usb-buck — Design Document

Brief: usb-buck (S14 run b)

Board review: usb-buck (adversarial, P8)

al-ee		
Sheet: /usb/		
File: usb.kicad_sch		
Title: usb-buck: USB port + ESD		
Size: A3	Date: 2026-07-28	Rev: 1
KiCad: E.D.A. 10.0.3		Id: 2/4

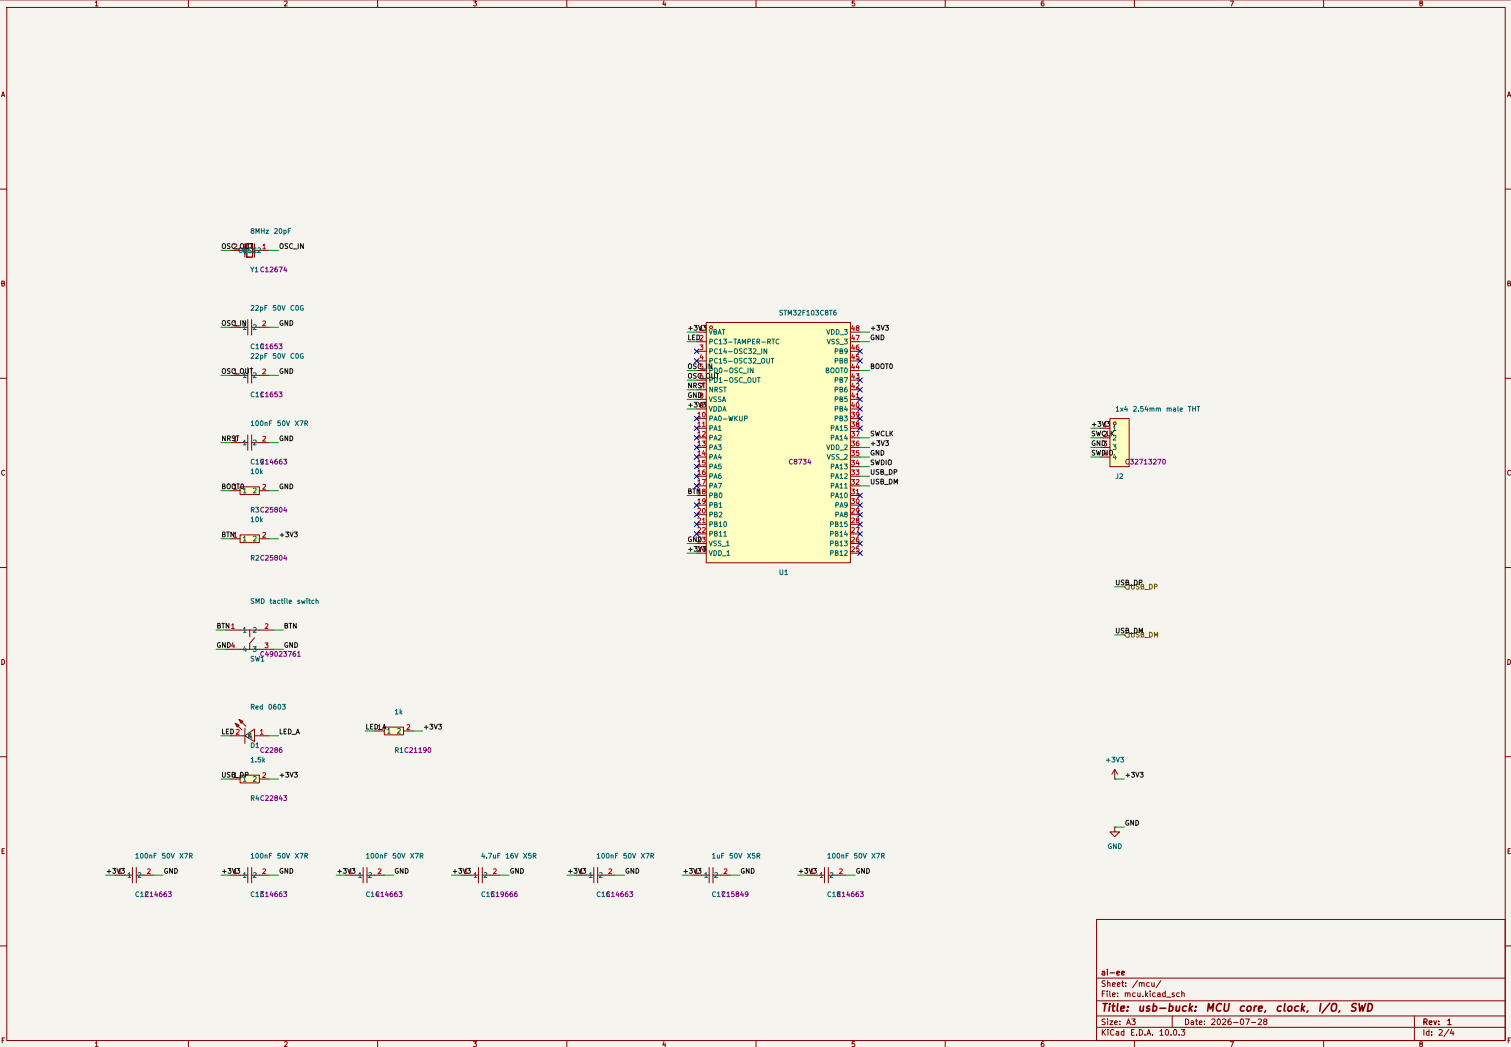
W1 sw1-pairing-unverified: SW1 (C49023761) has no manufacturer datasheet; {1,2}/{3,4} pairing follows the vendor symbol's internal bars. Failure mode if wrong: button reads permanently pressed (feature dead, NO damage; USB/ SWD/LED unaffected). WAIVED with a mandatory bring-up step: continuity-check SW1 pins 1-3 unpressed before firmware relies on the button. W2 usblc6-clone-vrwm: UMW USBLC6-2SC6 rated VRWM 5.0V vs USB legal 5.25V (top 0.25V unspecified). WAIVED for prototype qty 10; ORDER-TIME OPTION: swap to ST original (C7519, rated 5.25V, listed alternate in parts.json) - noted for H5.

reports/renders/usb-buck_top.png

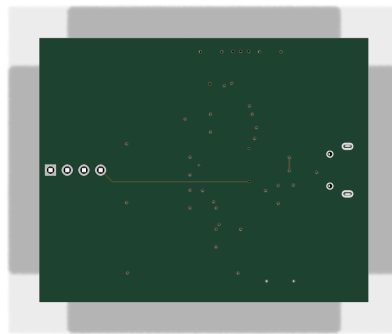
REFERENCE OUTPUT and "powering the board from the debugger would back-drive the buck output". As built (crop_right.png), pin 1 is marked only by a square THT pad - invisible once the header is soldered - and nothing identifies SWCLK/GND/SWDIO. A user with a clone ST-Link (whose 3.3V pin SUPPLIES power) has a 50% chance of connecting the ribbon reversed: SWDIO->3V3 backfeeds the rail, debug fails, and the AP63203 output is back-driven. Minutes to fix (four silk labels + a pin-1 tick), and check_silk can never see it - it checks geometry, not meaning.

W2 - J1 shield pegs and J2 leave JLC economy assembly unsoldered (warning) JLC economy PCBA is SMT-only. J2 (THT header) is planned as hand-solder per architecture - fine, bottom side is bare and access is excellent (usb-buck_bottom.png). But J1's four shield legs are PTH pads (2x round 0.7 mm, 2x slot 1.3x0.5 mm, all net GND) and NO document calls out soldering them. Fresh from assembly, the shield-to-GND bond (decision 5) and nearly all of the jack's rip-off retention hang on unsoldered pegs in plated holes; the SMD signal pads alone will not survive cable side-loads for long. Failure: shield ground goes intermittent, then the jack tears off. Needs one line in the bring-up/assembly instructions: hand-solder J1's 4 pegs + J2's 4 pins. (The two 0.5 mm-wide slots sit exactly at JLC's minimum slot width - inside capability, zero margin; dfm_check in S12 must confirm.)
